SUB-COMMITTEE ON DANGEROUS
GOODS, SOLID CARGOES AND
CONTAINERS
18th session
Agenda item 8

DSC 18/INF.7
9 July 2013
ENGLISH ONLY

REVISION OF THE GUIDELINES FOR PACKING OF CARGO TRANSPORT UNITS

Comments on the draft Code of Practice for Packing of Cargo Transport Units (CTU Code)

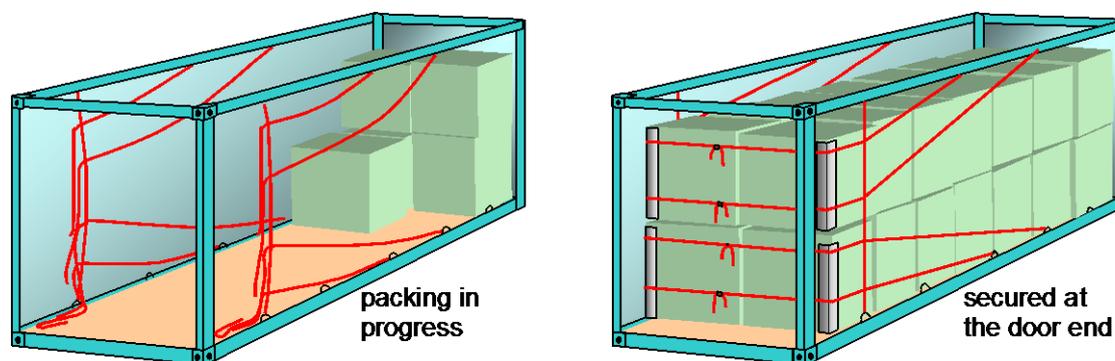
Figure 14.20 (page 250): it shows a modular system of a certain provider of lashing material which has obviously been copied from advertising material. The CTU Code should not show products of certain providers but illustrate the principle of cargo securing. Therefore, it should be replaced by the following illustration:
